From: Rob Wilson
To: "Kirsten Dell-Hartgers"; Garry Van der Krogt
Cc: Margaret Waller; Les Wilson
Subject: RE: Cashmere High - id 340 - monthly fire alarm and sprinklr testing
Date: Monday, 11 February 2019 6:21:37 p.m.
Attachments: [REDACTED]

Project: Cashmere High School – Argest Major Defect Remediation

N1 REMOVE EXIT SIGN
N2 PROVIDE EXIT SIGN OF PHOTO
LUMINESCENT TYPE
E EXISTING EXIT SIGN TO REMAIN

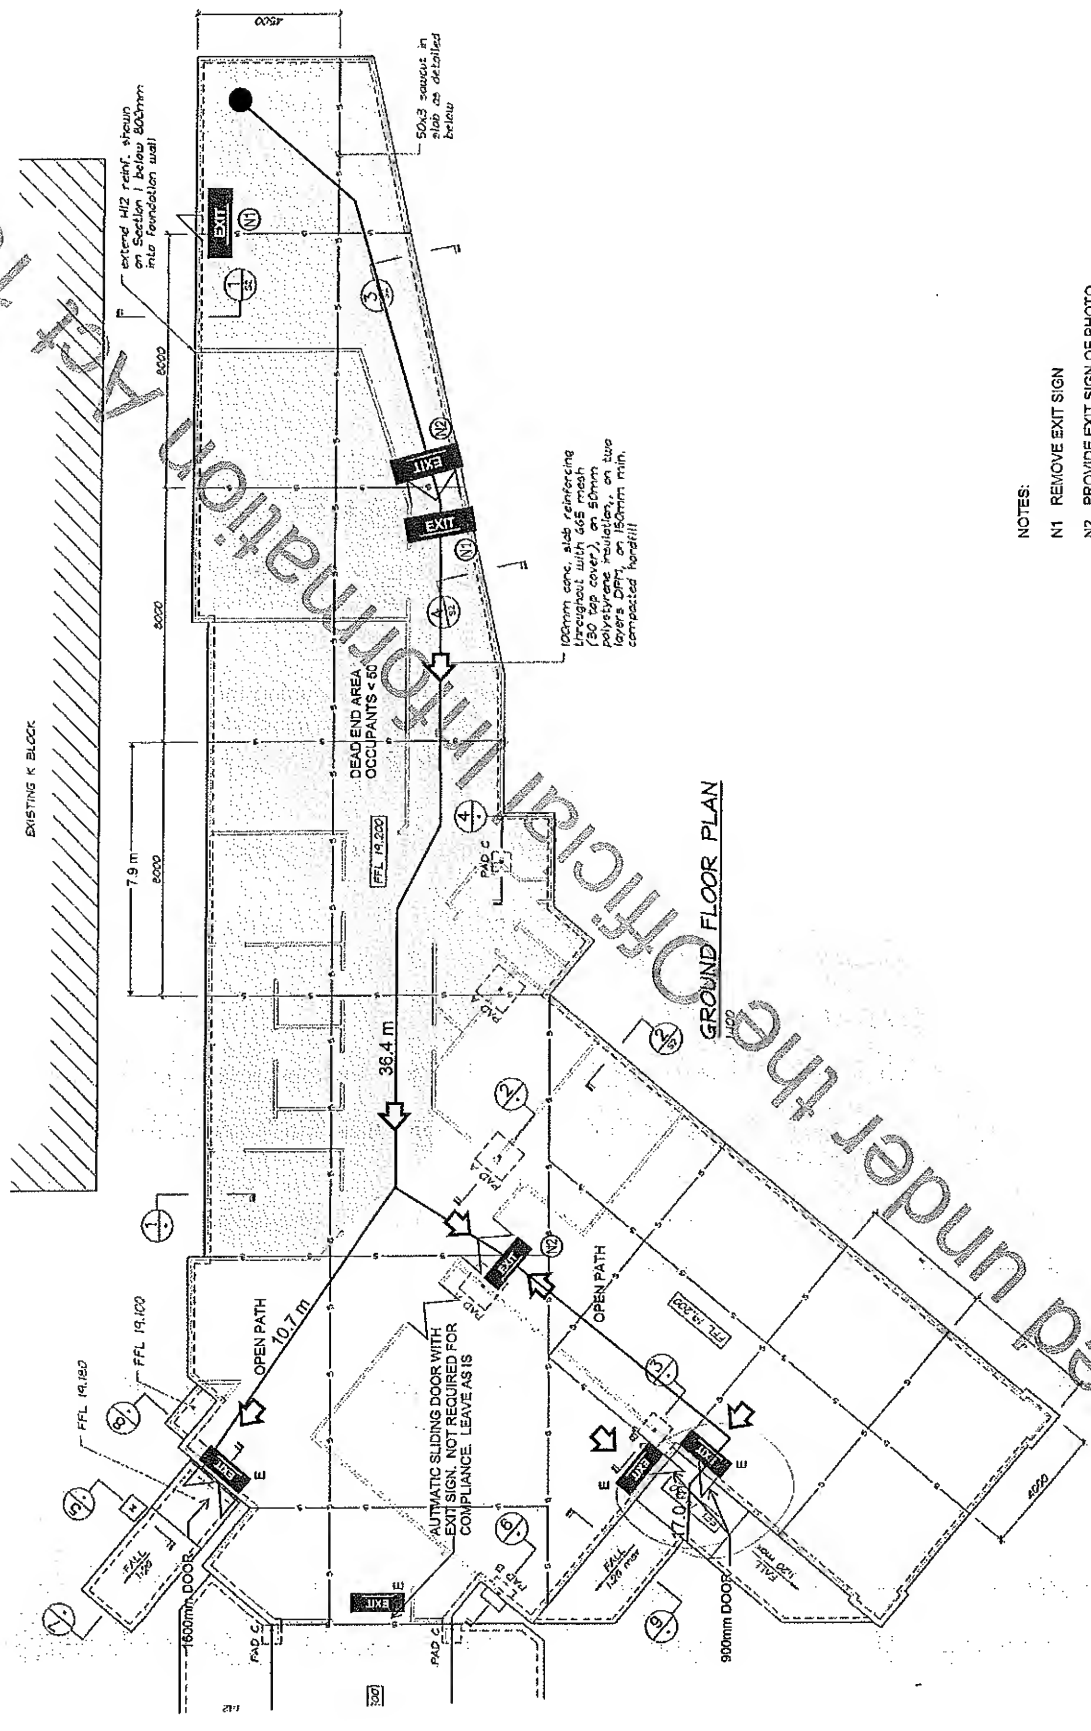
1. Add new EXIT sign above door in Classroom 2 into circulation space. Sign can be of the photo-luminescent type
2. Remove EXIT sign above door in circulation space into resource room
3. Add new EXIT sign above door in resource room into circulation space. Sign can be of the photo-luminescent type
4. Remove EXIT sign above final exit door in resource room.

2. The rear area in the building containing the Staff breakout, Staff Office and Resource Room is not to be occupied by more than 50 occupants.
3. Classroom 1 requires at least one escape route which is the final exit to the outside.
4. Classroom 2 requires two escape routes, these are,
 - a. The final exit to the outside,
 - b. The double doors into the building circulation space then via the main entry doors to the outside.
5. EXIT signs are to follow the designated escape routes above and be arranged as follows;
 - a. Add new EXIT sign above door in Classroom 2 into circulation space. Sign can be of the photo-luminescent type
 - b. Remove EXIT sign above door in circulation space into Resource Room
 - c. Add new EXIT sign above door in Resource Room into circulation space. Sign can be of the photo-luminescent type
 - d. Remove EXIT sign above final exit door in Resource Room.

2. Gym smoke detector and sprinkler head covered by store room exit

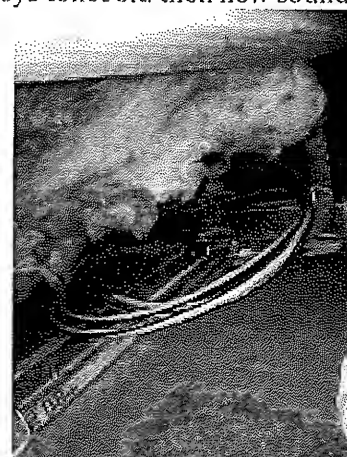
We understand this was sorted by Cashmere High School Caretaker however we found a Gym store room with plastic cover over sprinkler head held with blue tape. We removed the plastic cover.

Photo 1 shows plastic on, Photo 2 shows plastic removed

3. Gym toilet/changing rooms low sound levels

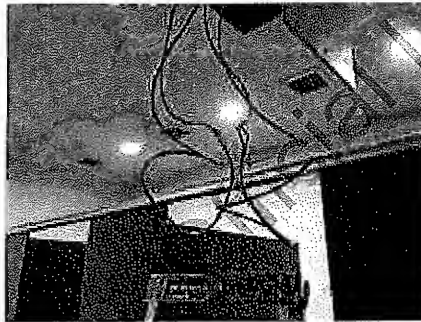
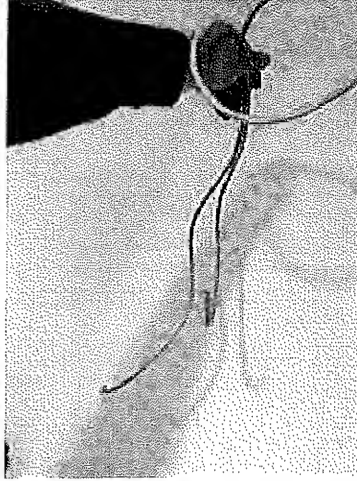
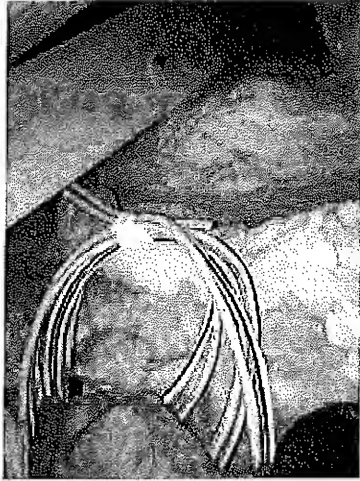
We investigated the evacuation devices in the Gym toilet/change areas and found several devices not working. Speakers which failed had no monitoring voltage which they should have if they were in circuit. We accessed the roof void and found five (5) open circuits on the evacuation feed. We expect these were wired for during installation but never brought through the gib. All five open circuits were junctioned which allowed some failed sounder to operate however two (2) still failed. Replaced these old Ampac sounders with new Pertronic ones which operated correctly. The old Ampac sounders were found to be problematic in the past including the grills falling off and were no longer sold as a result.

Photo 1 to 5 shows all 5 open circuits. Photo 6 & 7 show crimp joins to repair circuit. Photos 8 & 9 show old and new sounder in girls change. Photos 10 & 11 show boys toilet old then new sounders.

4. Amplifier 3 overloaded at 78watts (this needs urgent attention)

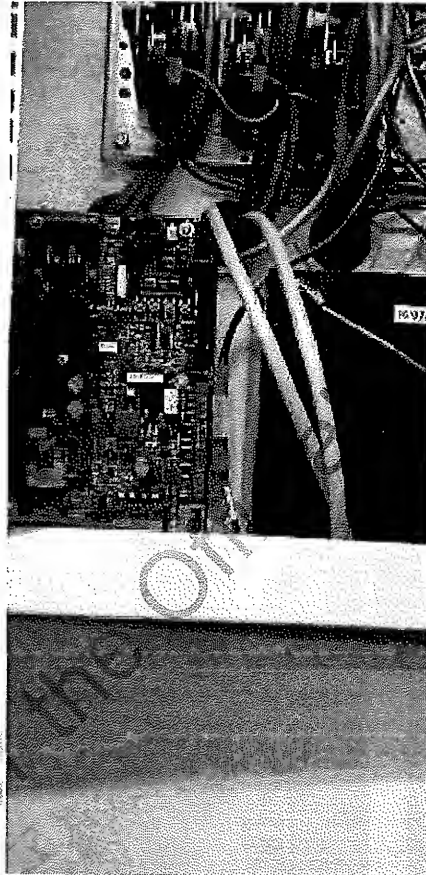
We carried out an impedance test on the evacuation feed to Amplifier 3 and found it to be just over 90Watts. The Amplifier is rated at a maximum of 50Watts so is well overrated. We purchased an FP1116 – 120Watt T-Gen which as stated is rated at 120Watt, 30Watts over the current evacuation load. This was installed, made into the master amplifier and tested ok.

Photo 1 shows the new 120Watt Amplifier installed in the MX1 panel. The green normal light is top centre and the green LCD display is showing normal screen.
